Protect St. Andrews Shoreline

Proposed Infill Plan

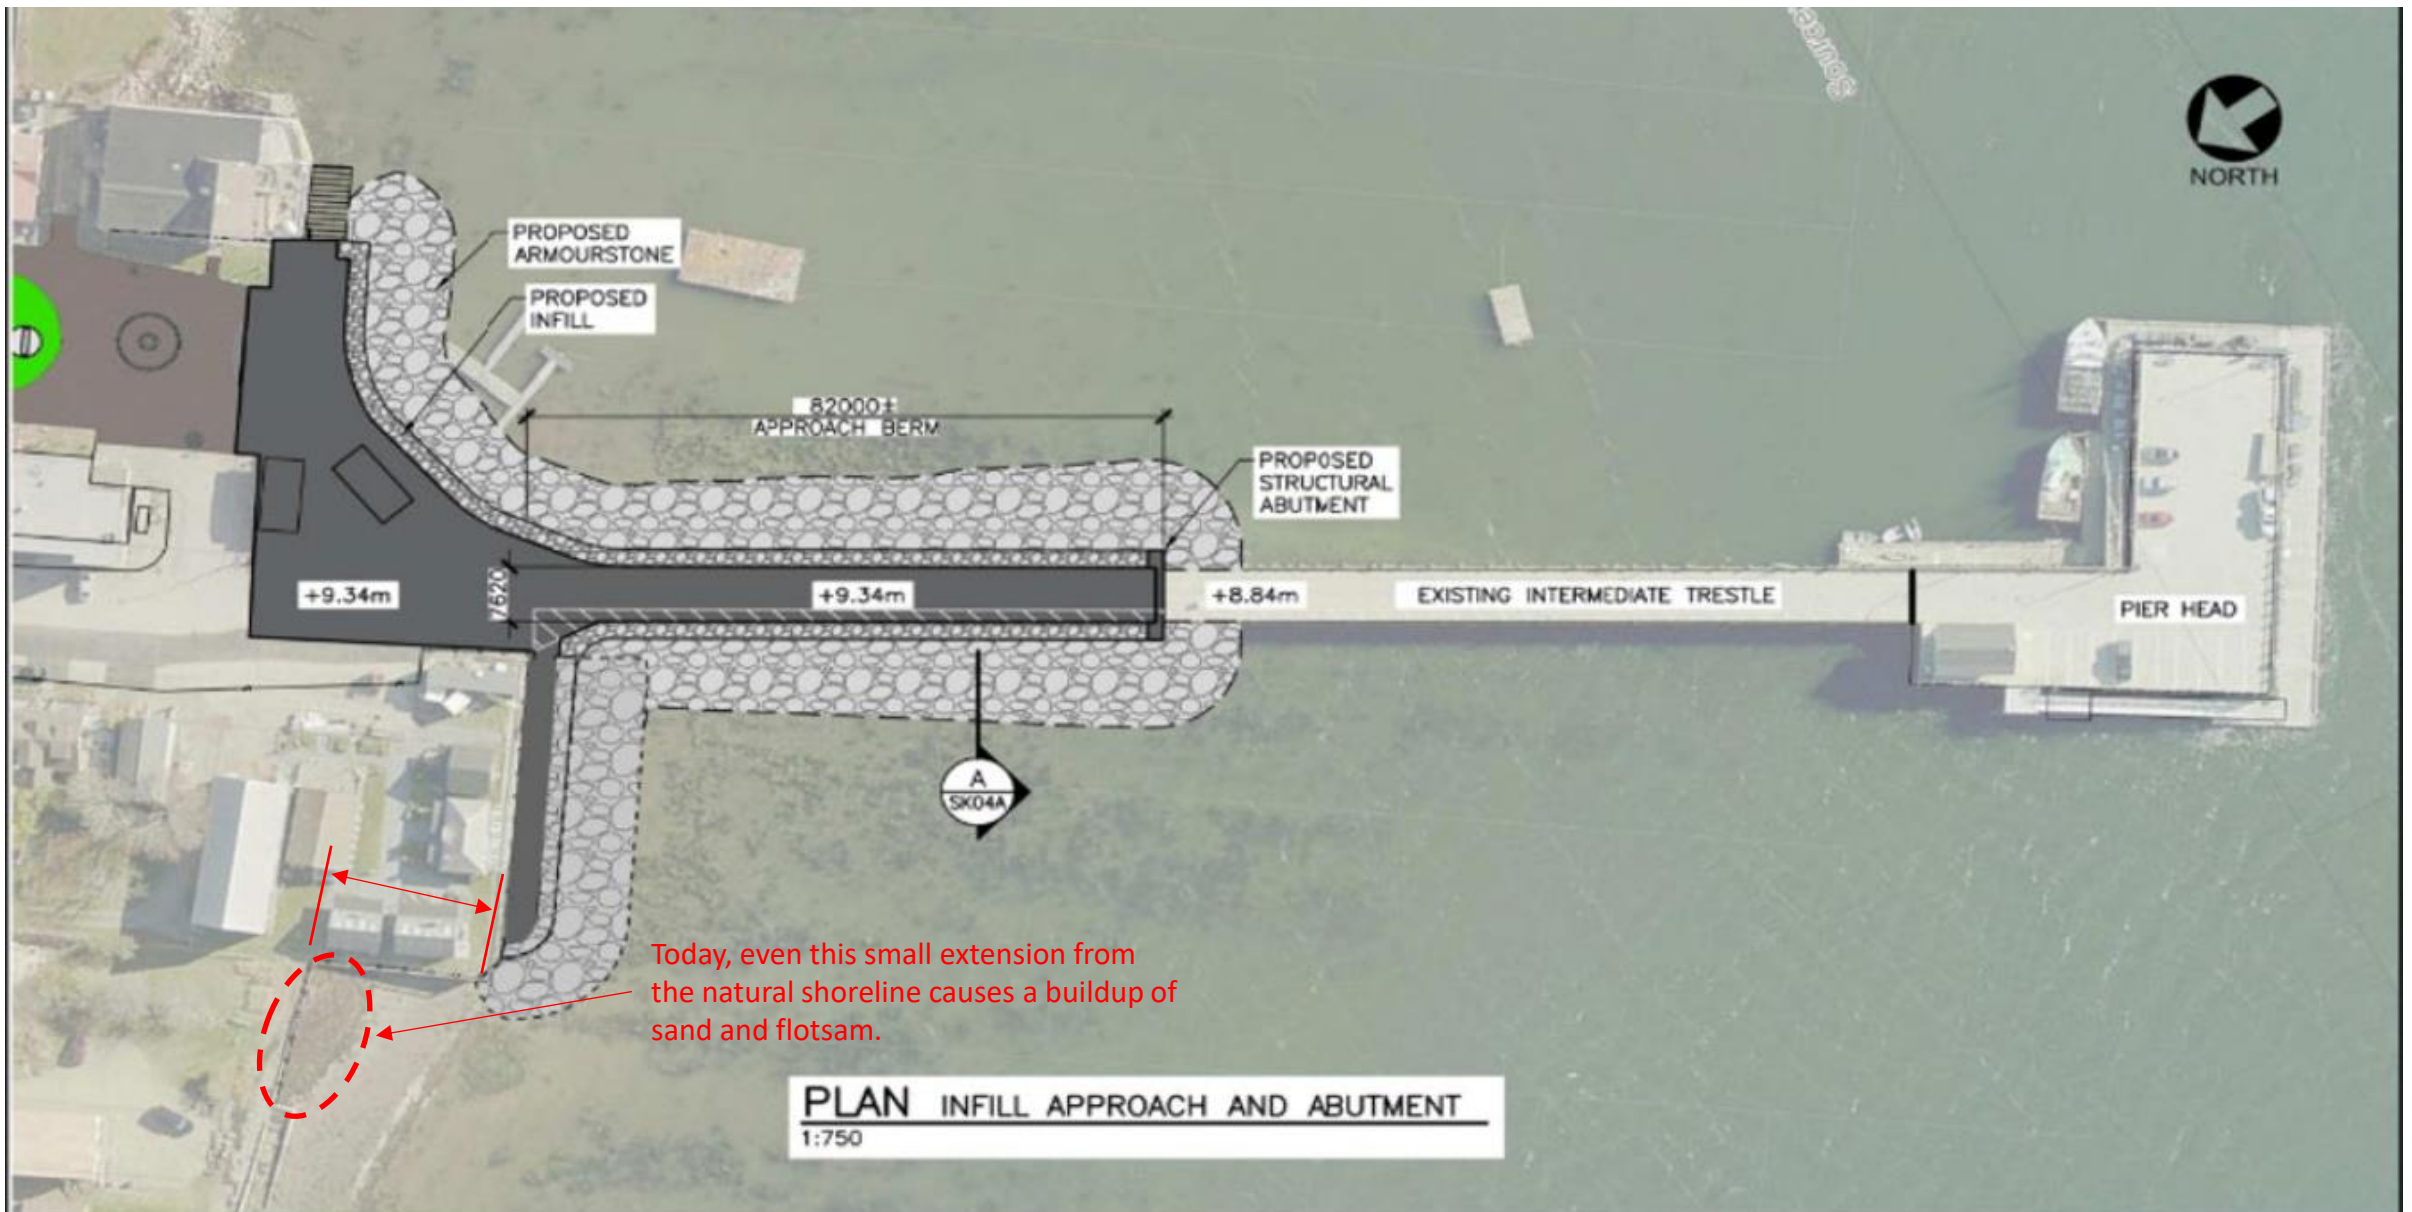
- Concrete-topped trestle on granular fill & steel piles
- 41 m long × 7.6 m wide (~4 545 m²)

Shoreline Erosion Risk

- Alters longshore currents
- Creates recirculation zones
- Cuts into shoreline

1. Demand a full environmental impact study
2. Write to your councilors & MLA
3. Share & tag @TownOfStAndrews

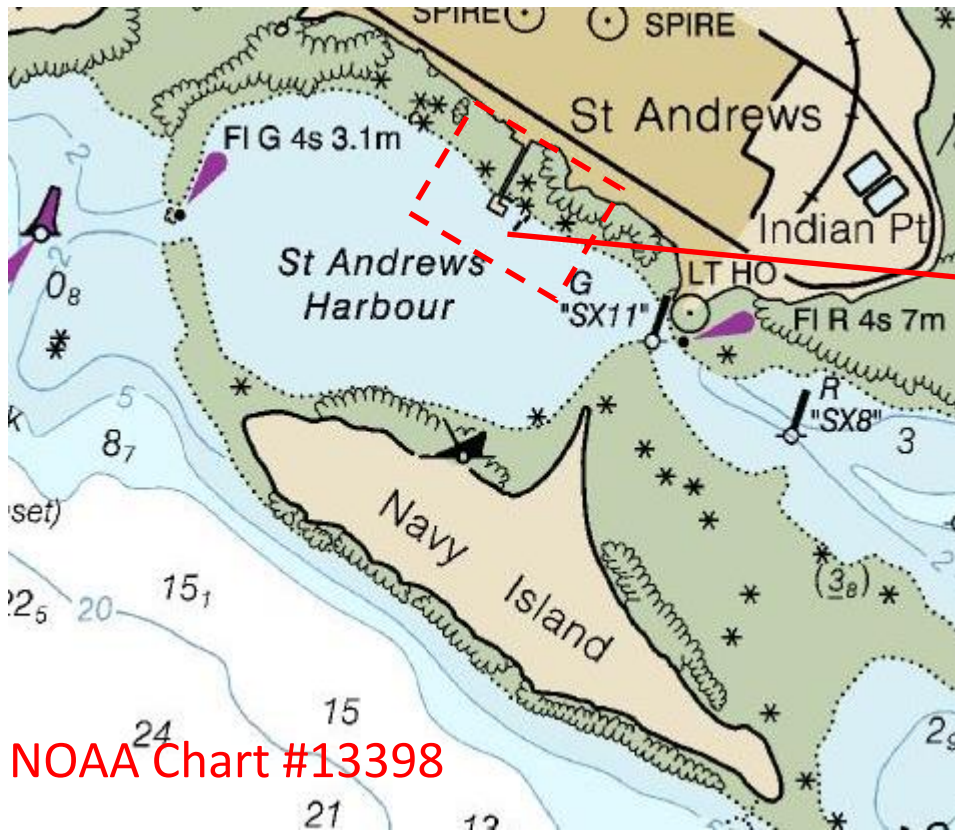
Presently, St. Andrews wharf has open space for longshore currents to pass through.

The harbourfront has significant longshore currents even on calm days. The lines of foam in this picture are wakes from the wharf pilings. This photo was taken at $\frac{3}{4}$ flood tide when the longshore current flowing from the northwest was in excess of one knot. During storm conditions, longshore currents are significantly higher.

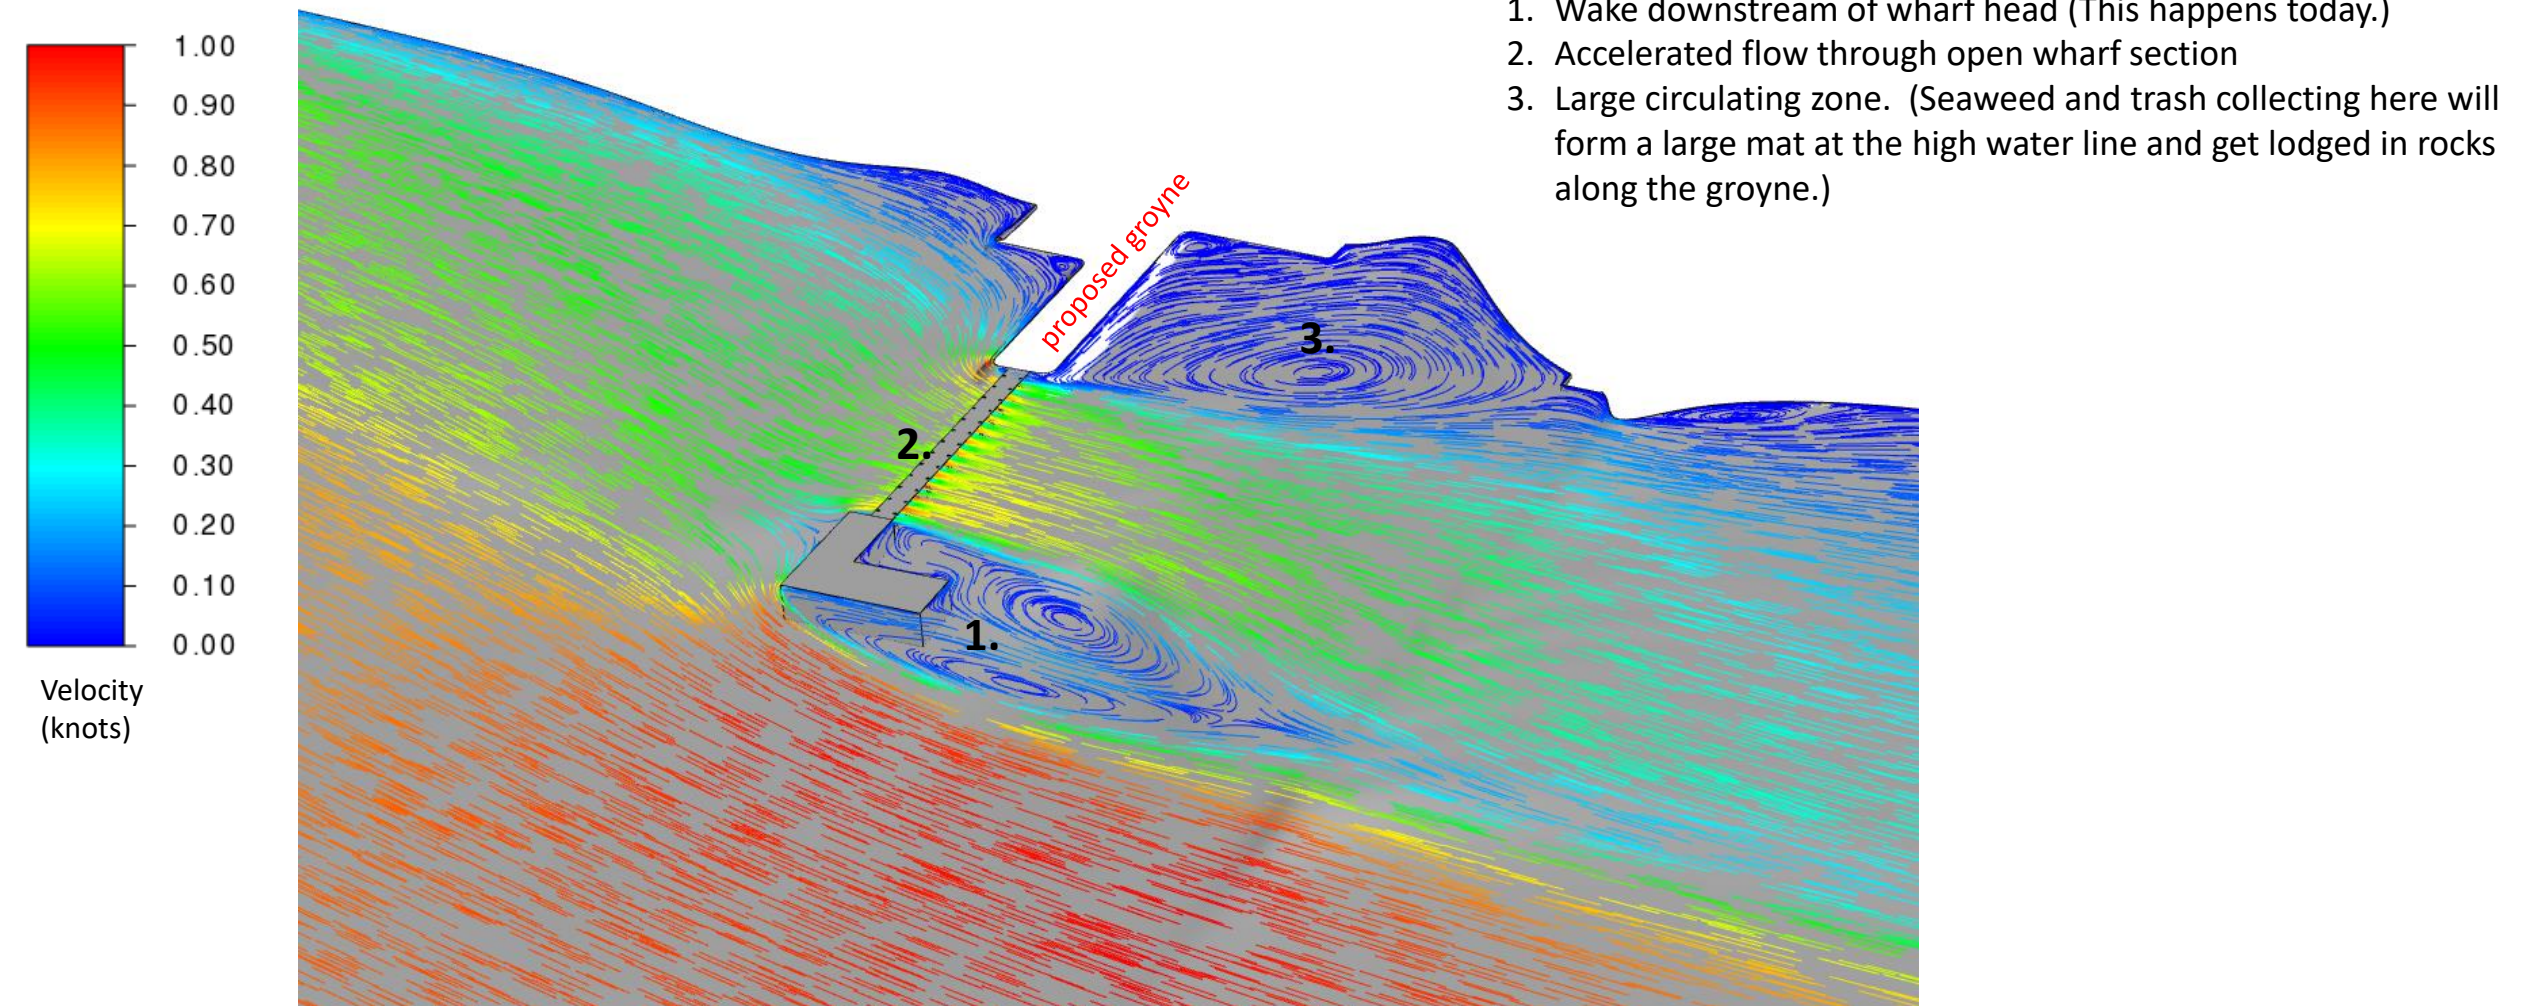
This is a contour map of the harbour floor near the wharf. Elevation zero is the average low tide level.

The streak lines in the rendering below show flow patterns on the water surface when the current in the harbour is passing the wharf head at a speed of one knot. They show a large recirculating zone (3) that will fill with trash and rotting seaweed in a line of sight from five nearby shorefront restaurants.

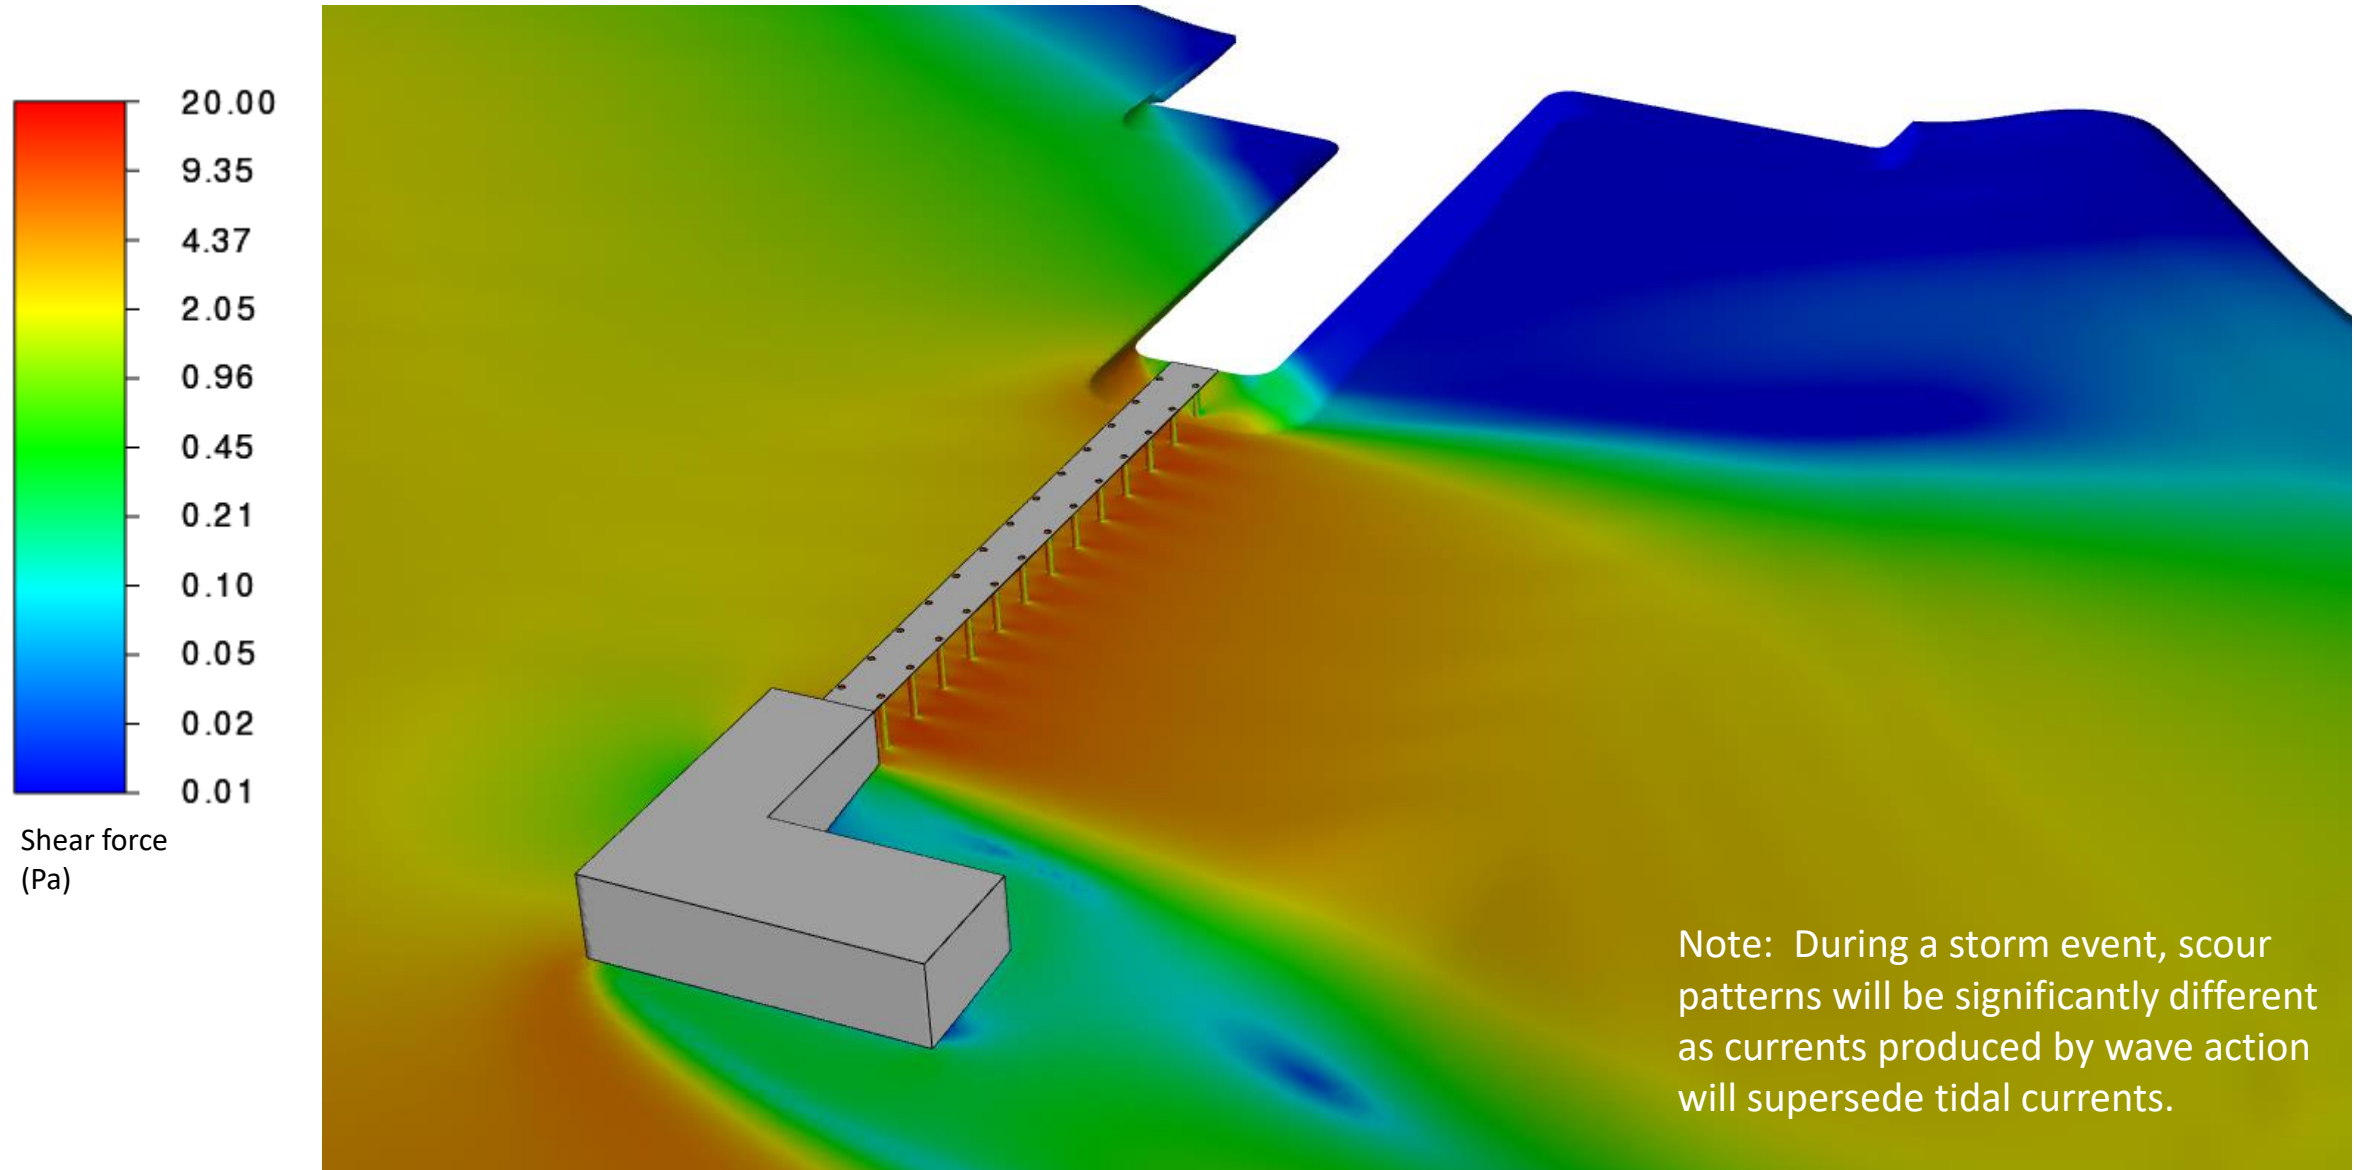
The illustration below is a contour map of the scouring forces acting on the harbour floor in the vicinity of the wharf. The red regions indicate zones most at risk for erosion and the blue where deposits will occur.
